**PROJECT SPECIFIC PLAN FOR EXCAVATION CONTROL  
OF AREAS 3B, 4B, AND 5  
(SUPPLEMENT TO 20300-PSP-0011)**

**FERNALD CLOSURE PROJECT  
FERNALD, OHIO**

**20810-PSP-0006  
REVISION 1  
FINAL**

As noted in the above paragraph, excavation in Area 3B and Area 4B has commenced. All variances documenting the work in these areas, issued under the Project Specific Plan for Area 3A/4A Excavation Characterization and Precertification, 20200-PSP-0009, are attached as Appendix A.

FIGURE 1. LOCATION OF REALTIME REPLACEMENT SAMPLING AREA

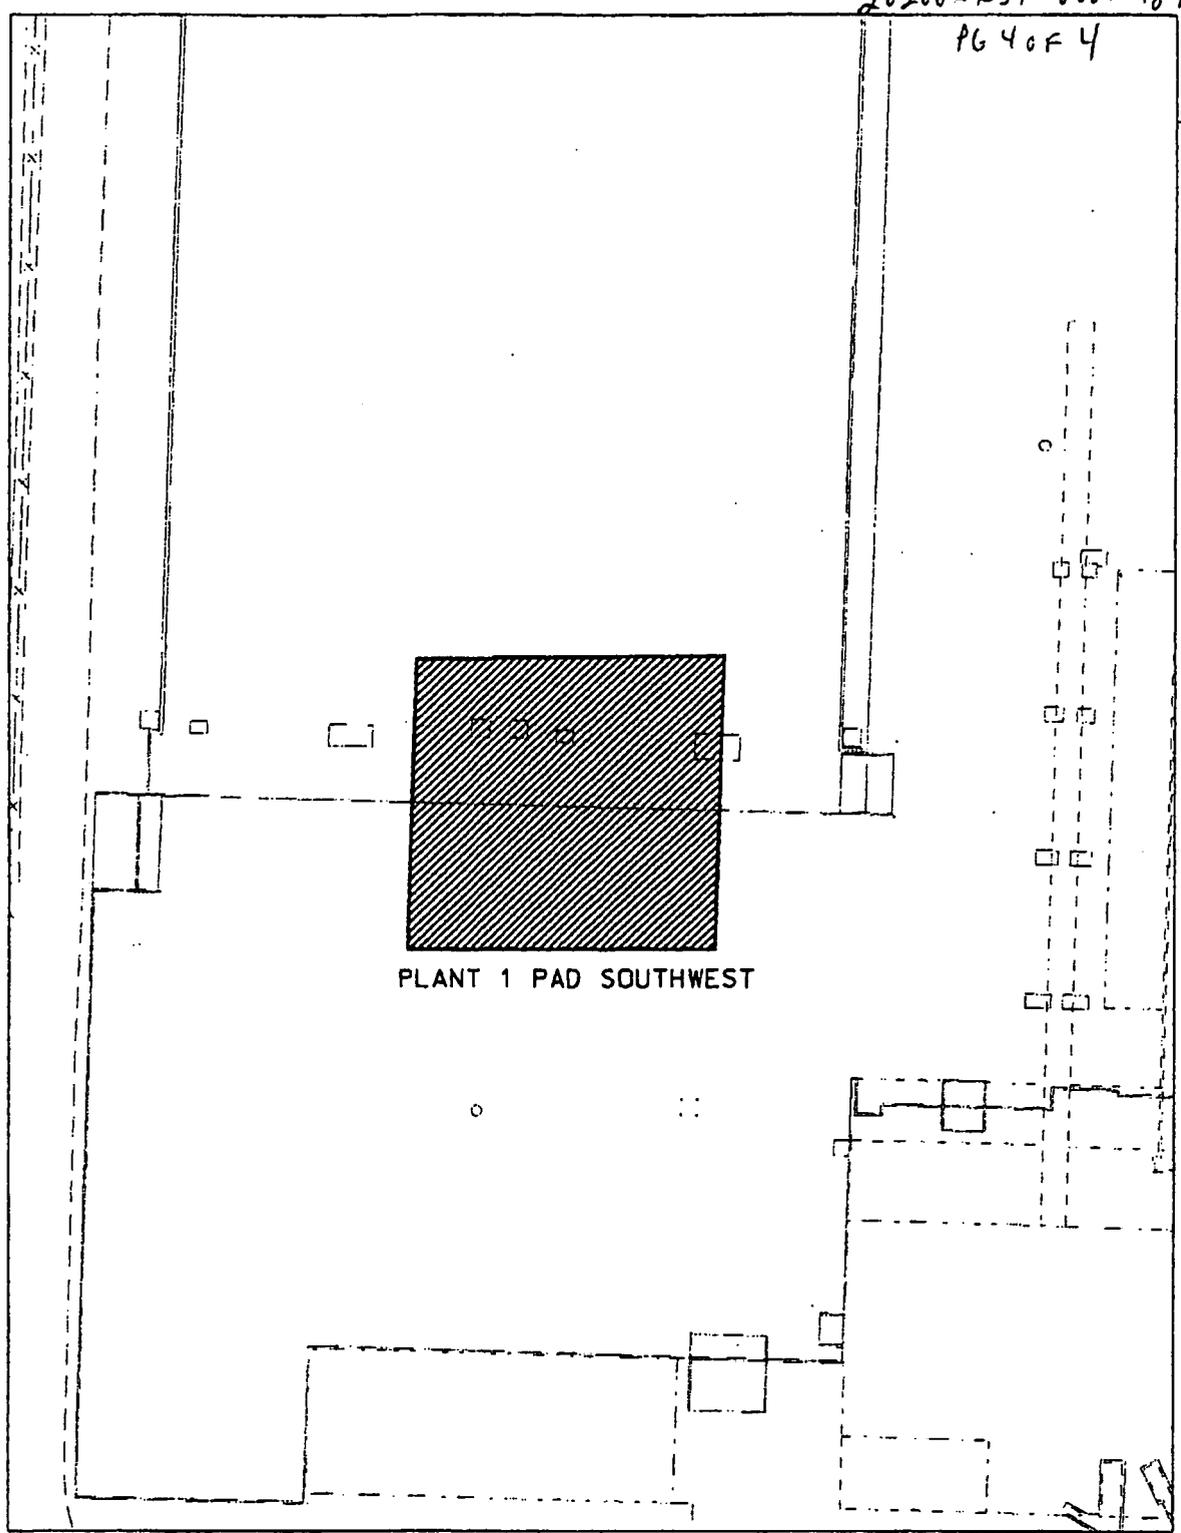
This Variance/Field Change Notice (V/FCN) documents the collection of grab soil samples to replace the real-time scanning requirements in Area 3B for total uranium. The area is located on the western side of Area 3B (see Figure 1). This particular area is not in the 3A/4A scope. A formal PSP to describe the remainder of Area 3B is in process and will be submitted in the near future. Surface samples are to be collected from the floor and sidewalls of lift 4 of this area to support the lift scan requirements for this lift. This area is approximately 120' by 120'. Coordinate with the Construction Lead and/or WAO Representative for this sampling event.

FIGURE 1. V/FCS 2020-PSP-0009-192

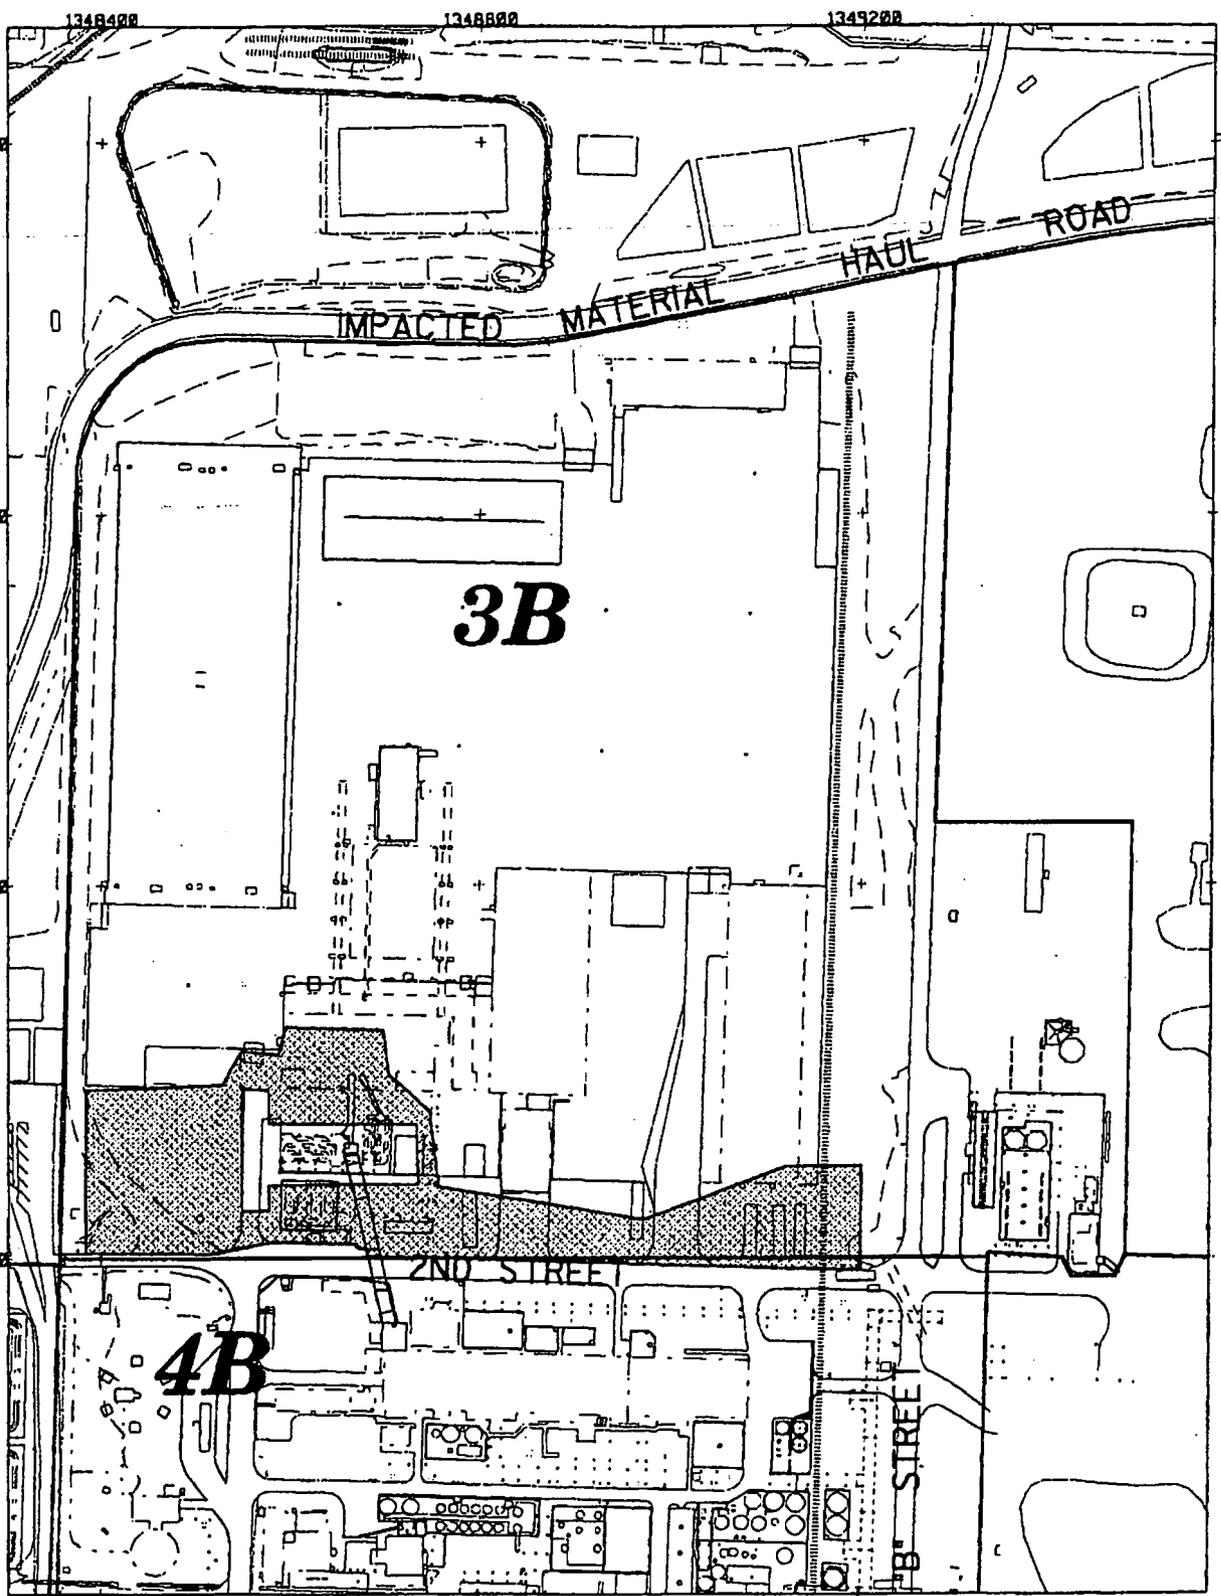
This Variance/Field Change Notice (V/FCN) documents the collection of grab soil samples along the southern end of Area 3B just north of Second Street for total uranium. This sampling replaces the real-time scanning requirements. This particular area is not in the 3A/4A scope. A formal PSP to describe the remainder of Area 3B is in process and will be submitted in the near future. Samples are to be collected in the area defined in Figure 1. This area is approximately 89,800 square feet. Coordinate with the Construction Lead and/or WAO Representative for this sampling event.

FIGURE 1. V/FCN 20200-PSP-0009-197

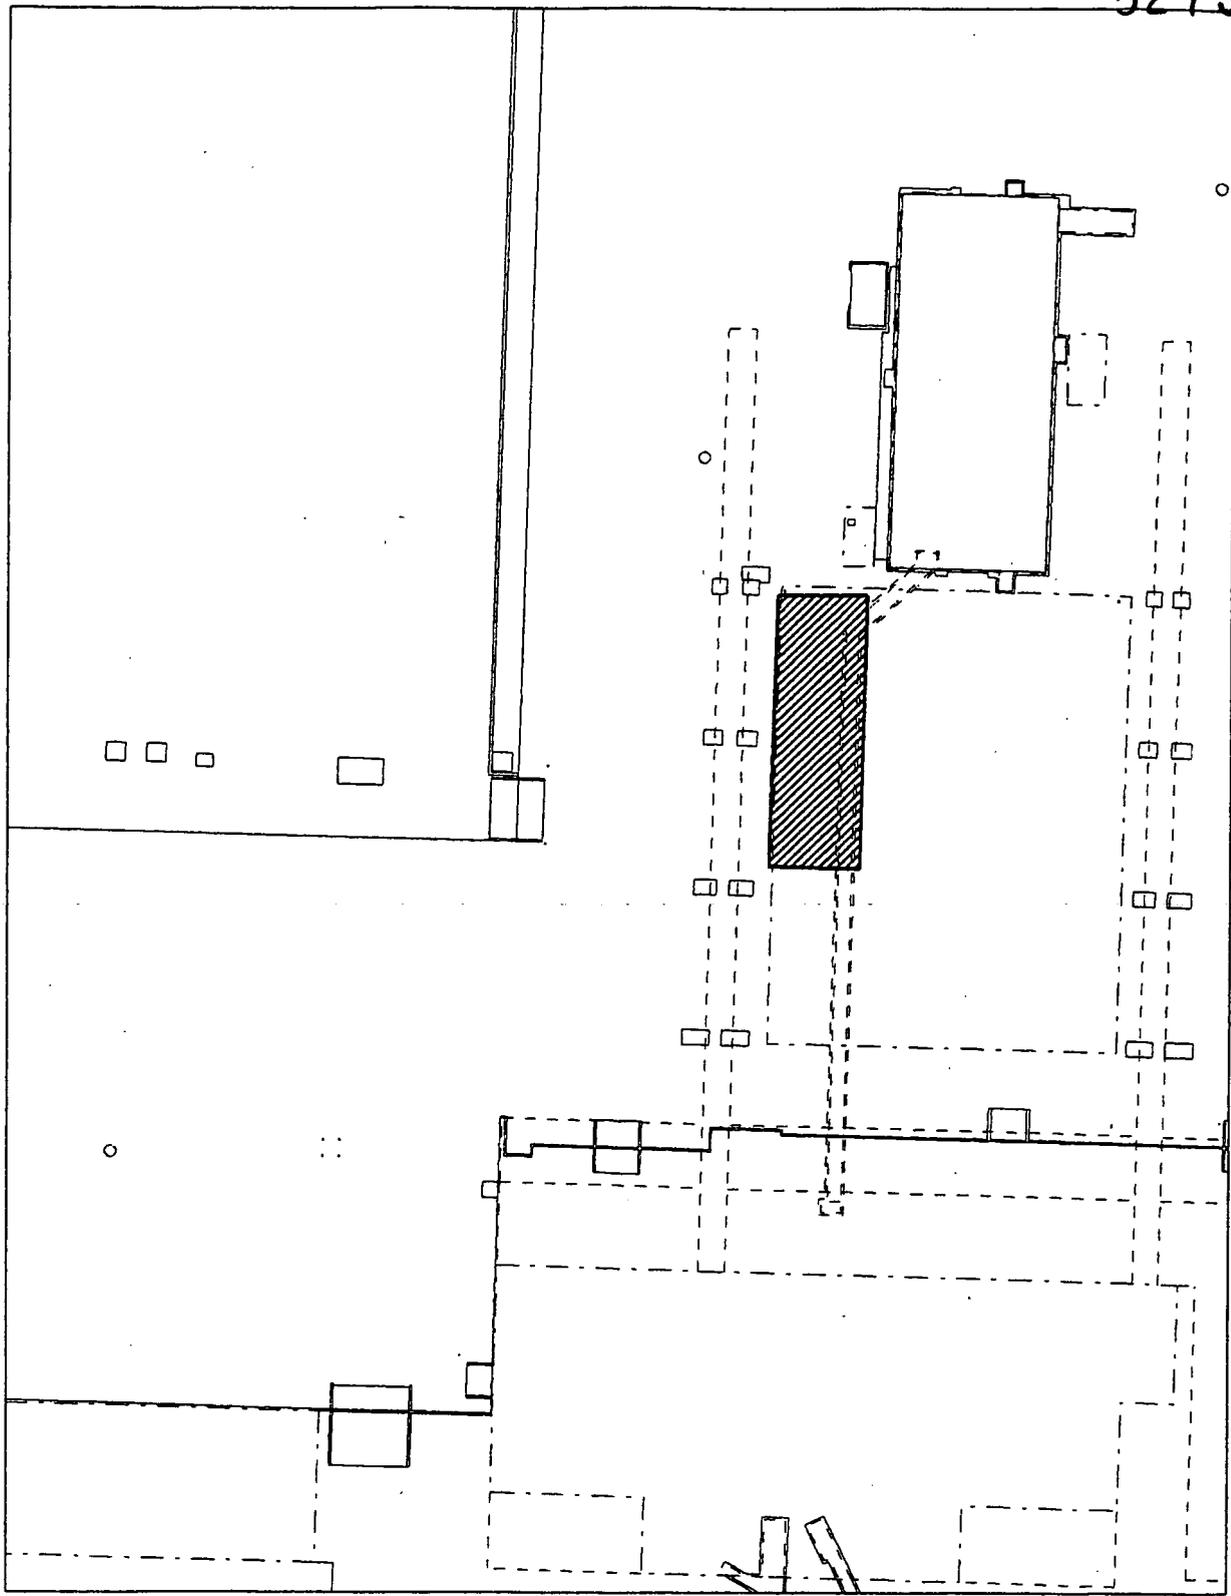
This Variance/Field Change Notice (V/FCN) documents the collection of grab soil samples along the utility trench by the former Plant 1 Ore Silos in Area 3B. This sampling replaces the real-time scanning requirements. This particular area is not in the 3A/4A scope. A formal PSP to describe the remainder of Area 3B is in process and will be submitted in the near future. Samples are to be collected in the area defined in Figure 1. This area is approximately 8' X 100'. Coordinate with the Construction Lead and/or WAO Representative for this sampling event.

FIGURE 1. V/FCN 20200-PSP-0009-198

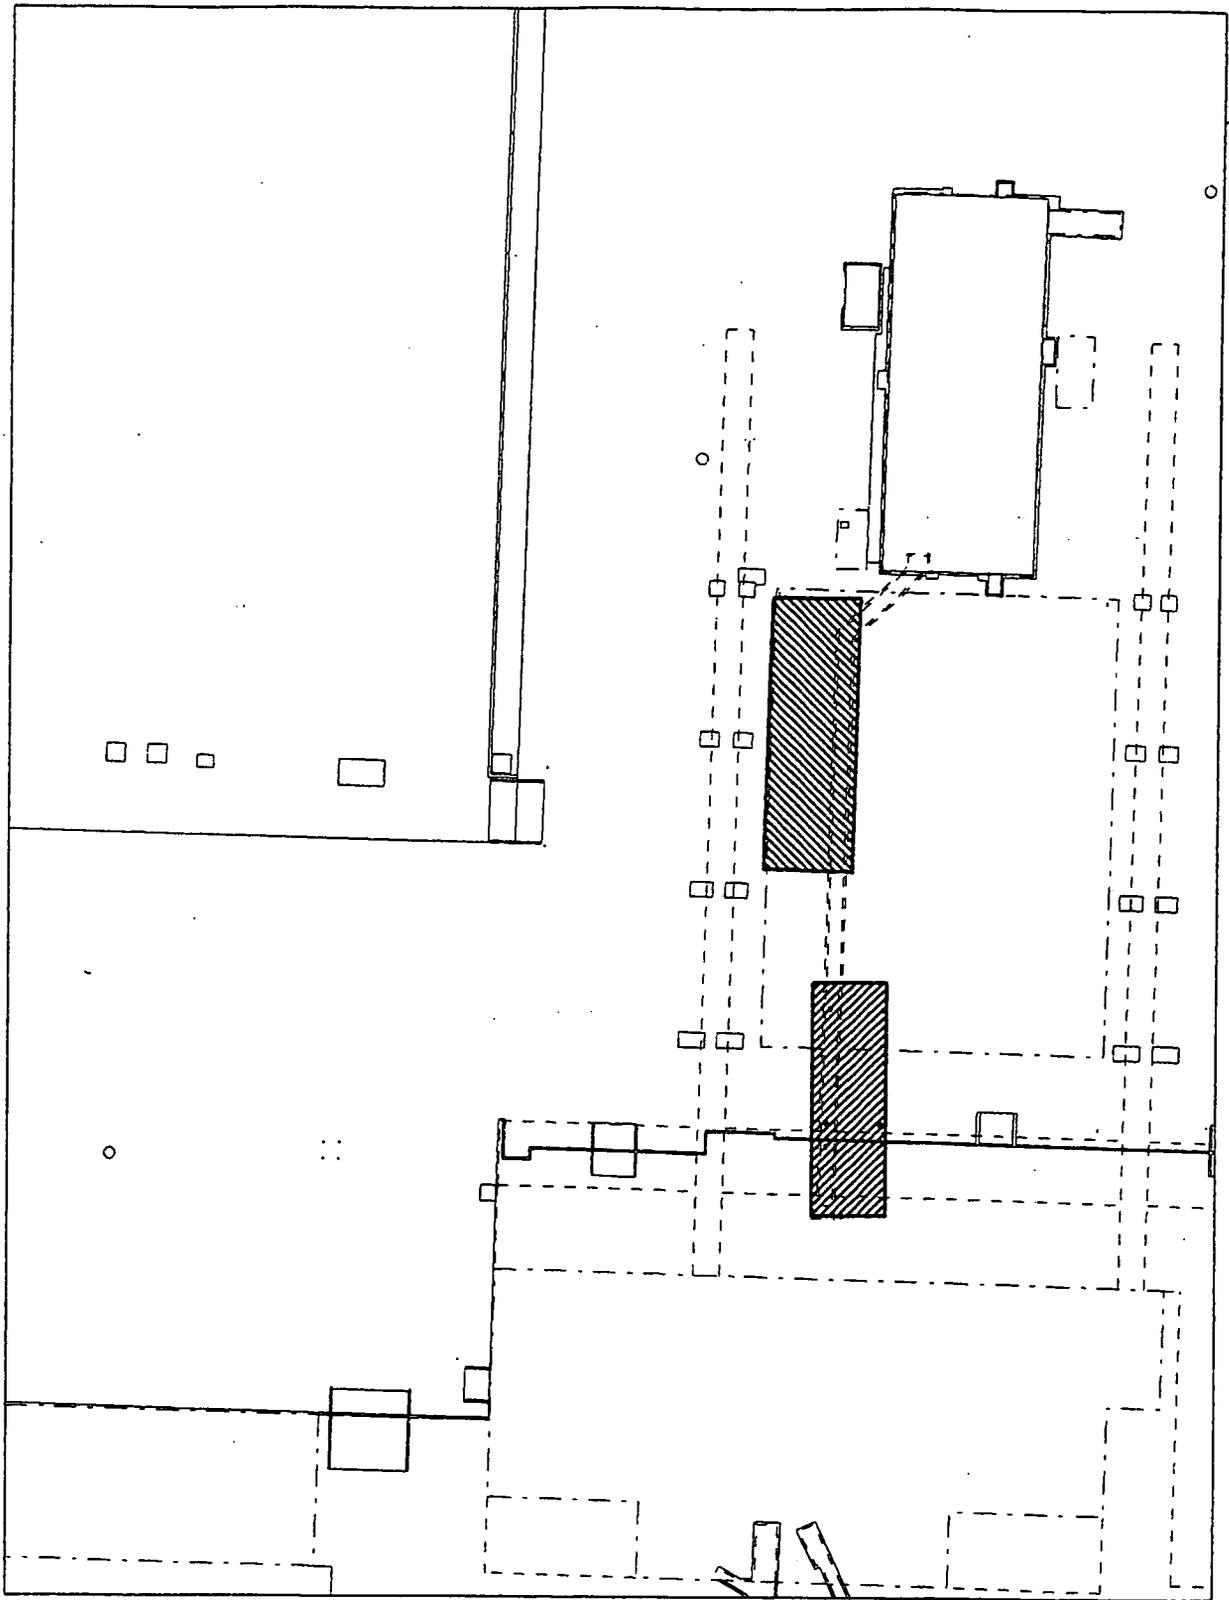
This Variance/Field Change Notice (VFCN) documents the collection of grab soil samples along the utility trench by the former Plant 1 Ore Silos in Area 3B. This area is an extension to the south of the area sampled under variance 20200-PSP-0009-197. This sampling replaces the real-time scanning requirements. This particular area is not in the 3A/4A scope. A formal PSP to describe the remainder of Area 3B is in process and will be submitted in the near future. Samples are to be collected in the area defined in Figure 1. This area is approximately 8' X 100'. Coordinate with the Construction Lead and/or WAO Representative for this sampling event.
